REQUEST FOR INFORMATION FORM

Project No.:	01-26-020 (26766)	RFI No.:	RFI-126020-012
Date:	August 25, 2026	Discipline:	Piping
Project Name:	26766 – BA2107 TLE End-of-Life Replacement		
Subject:	ASC Fig. 40 Riser Clamps – Level Bridle Piping		
Specifications/Documents/Drawings Referenced or Impacted:			
Isometric FA2107-TRIM Rev. 1.1, Sheets 1 and 2, Note 9 ASC Fig. 40 Riser Clamp – Standard, data sheet ASC Fig. 261 Extension Pipe or Riser Clamp, data sheet

DWG. NO. FA2107-TRIM

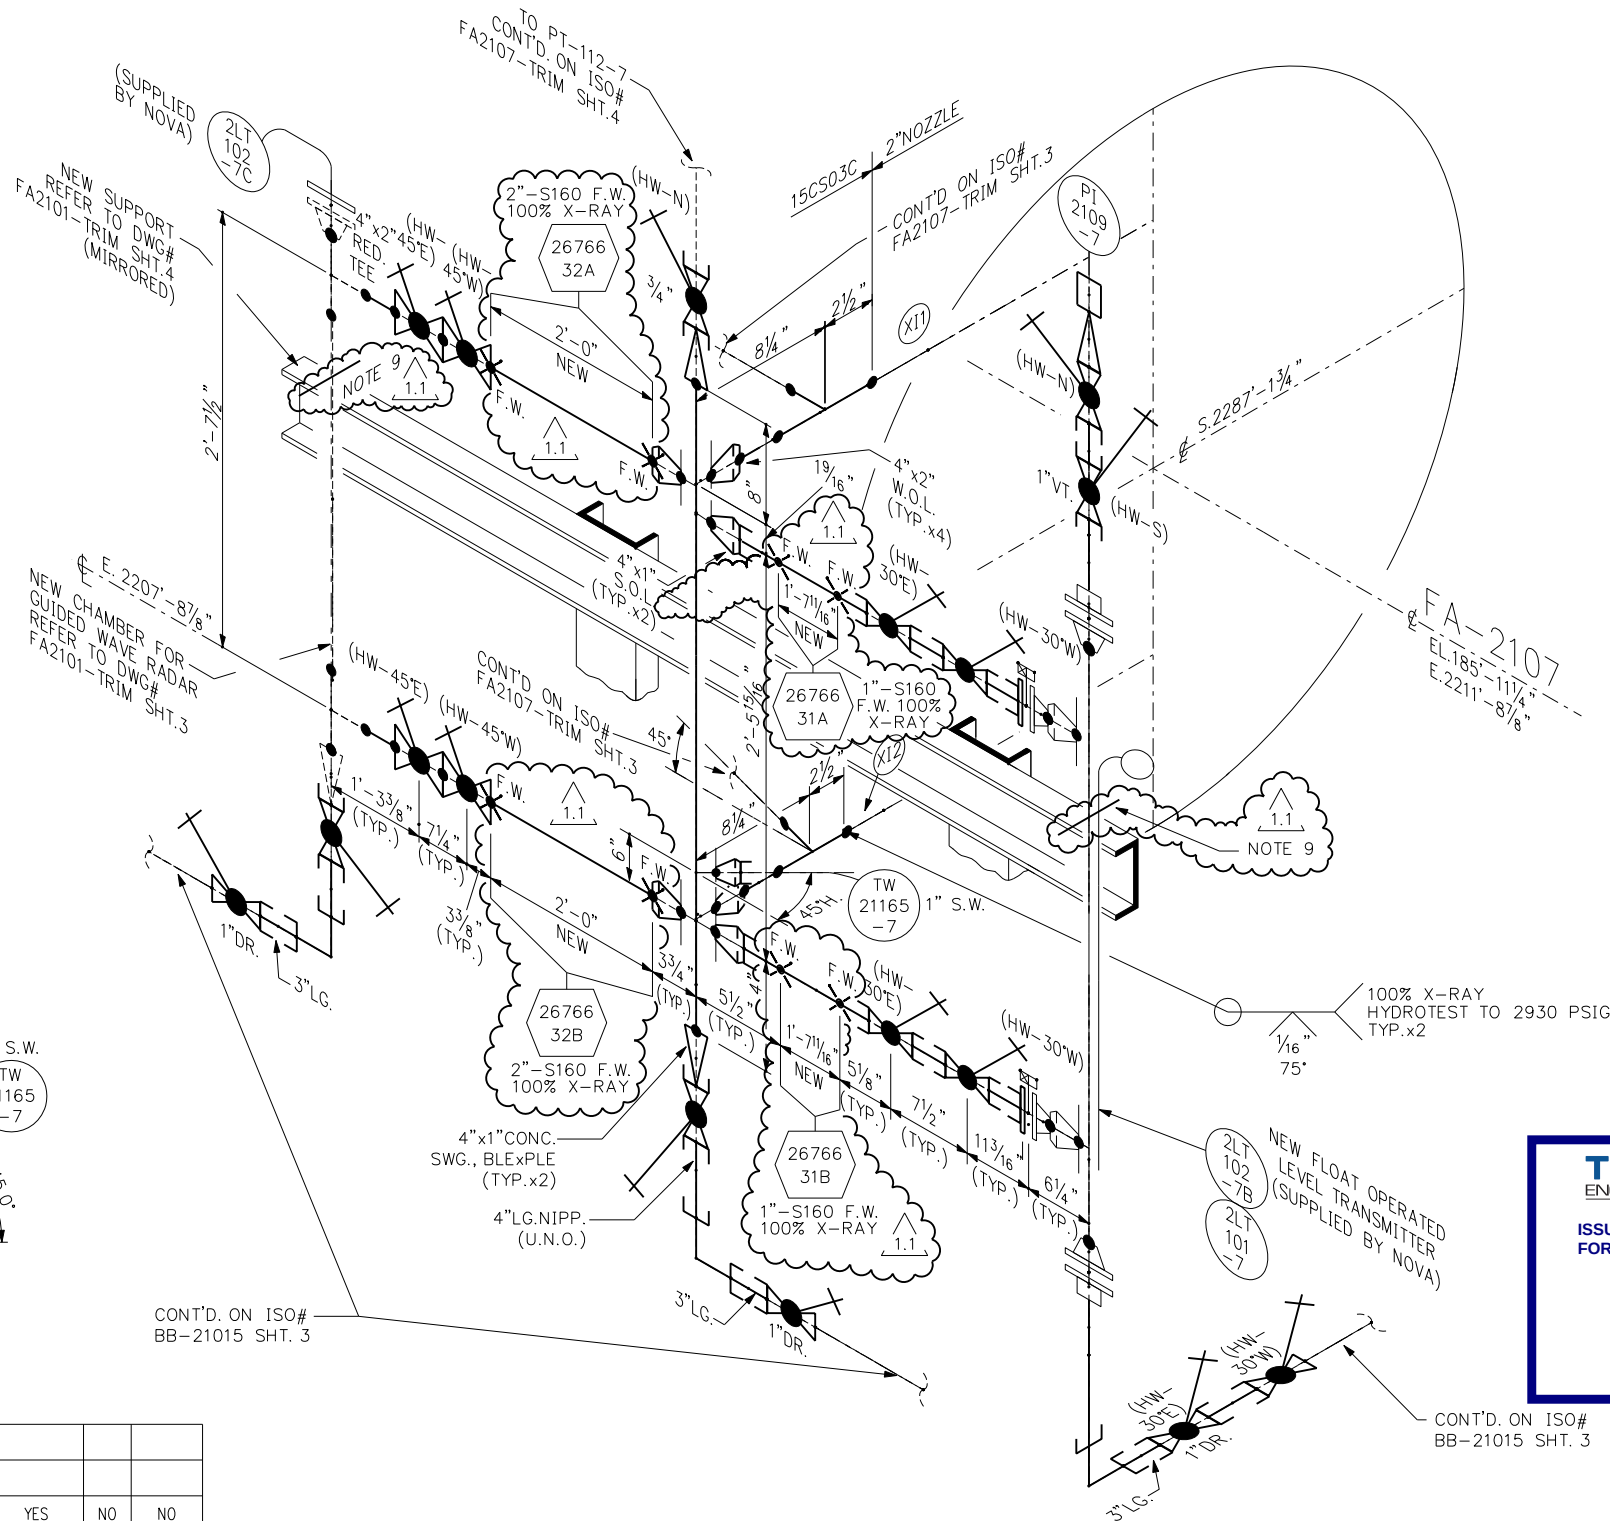
Question or Description of Issue:			
Note 9 of isometric FA2107-TRIM Rev. 1.1, Sheets 1 and 2, specifies ASC Fig. 40 riser clamps on the FA-2107 level bridle piping. Note 9 states: <i>“REMOVE INSULATION AND INSTALL CS ASC RISER CLAMP FIG.40. RISER SHOULD REST ON STEEL. RE-INSULATE PIPING TO MATCH EXISTING.”</i> The 4" Fig. 40 clamps are quoted at \$822.39 each and are not available until early November. ASC originally quoted Fig. 261 clamps, which are available from stock but carry a lower load rating than the specified Fig. 40. Published ratings for both figures are given in the attached data sheets. The ASC data sheet for the Fig. 40 also states that load is carried by shear lugs welded to the pipe. Shear lugs are not identified or detailed on the scope drawings, and Note 9 instead indicates that the riser is to rest on steel. Welding shear lugs to the FA-2107 trim piping (4"/2", pipe class 15CS03C, 1950 psig at 650°F, ASME B31.3 normal fluid service) would introduce additional welding, examination and hydrotest requirements beyond those currently shown.

Originator's Recommended Solution:			
Please review the required support and restraint loads for the level bridle piping and advise whether ASC Fig. 261 clamps are acceptable in lieu of the specified Fig. 40. If the Fig. 261 is not acceptable, please advise whether a field-fabricated support such as angle iron with a tight U-bolt or similar arrangement may be used in order to avoid welding to the existing piping. Please also confirm whether shear lugs are required and, if so, issue the applicable detail together with the associated examination and test requirements.			
Urgency:	Medium (3 days)		
Originator:			
_____ Nitin Joshi Name		_____ Signature	_____ PC Title
		_____ August 25, 2026 Date
